CITY OF FLINT
WATER POLLUTION CONTROL

BID PROPOSAL P25000515

WATER POLLUTION CONTROL
SURVEILLANCE IMPROVEMENTS

ADDENDUM #1

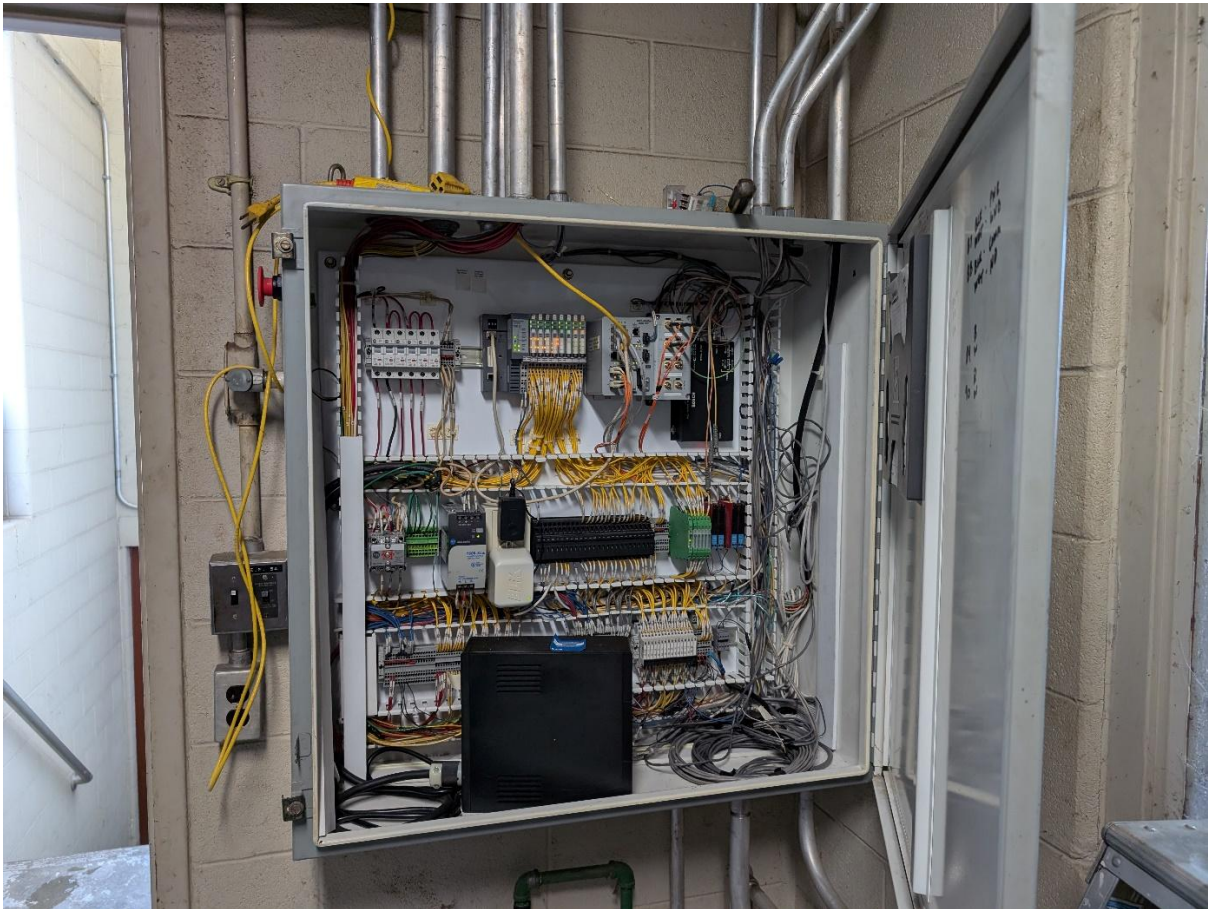
Q35: Will our team be able to reuse existing ridged conduit found throughout the location?

A35: Possibly, depending on the location and potential future projects.

Front of Bar Screens

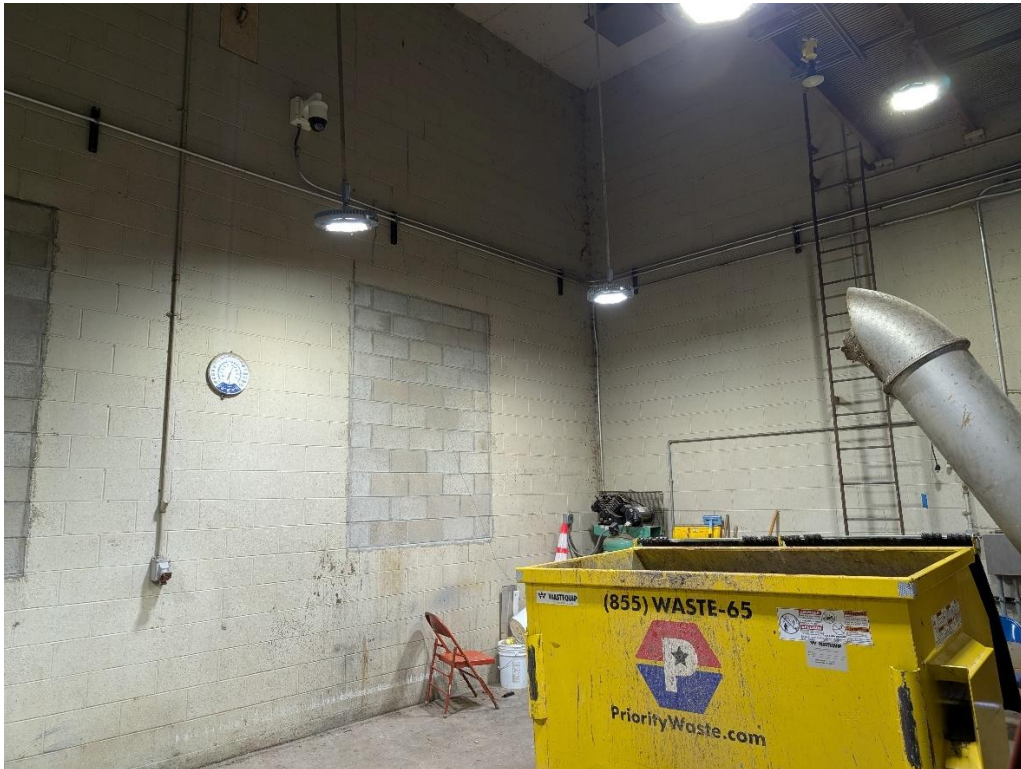
The probably best location of the new camera is on the ceiling between the two bar screens or slightly behind to get the best view of both the front and rear of the bar screens and the conveyor.
